INITIAL ELECTRICAL ASSESSMENT REPORT (EAR)

Factory Name: **Brandix Casual Wear Ltd**
Address: **Plot No 61-71+85 Comilla EPZ Comilla Chittagong
Bangladesh**
Assessor: **Bureau Veritas**
Date: **07 Jun 2014**

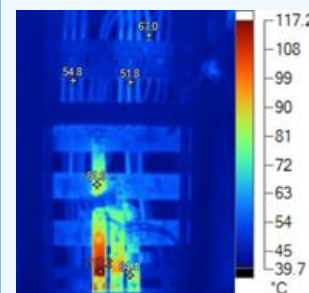
Question:	The substation room has the required fire rating/protection and is physically separated from the remainder of the building.
Priority Level:	High
Non-Compliance Level:	2
Description:	Although the substation room is physically separated by more than 4.5 meter away from main production shed but a chemical store room is located within 4 feet from it. Also the substation room is not fire rated.
Source of Findings:	Photograph: The substation room is physically separated but not fire rated.

Suggested Plan of Action:	Provide adequate fire rating for substation room.		
Suggested Deadline Date:	03 Aug 2014		
Standard:	Alliance Standard Part 3 Section 3.4.2.1.4
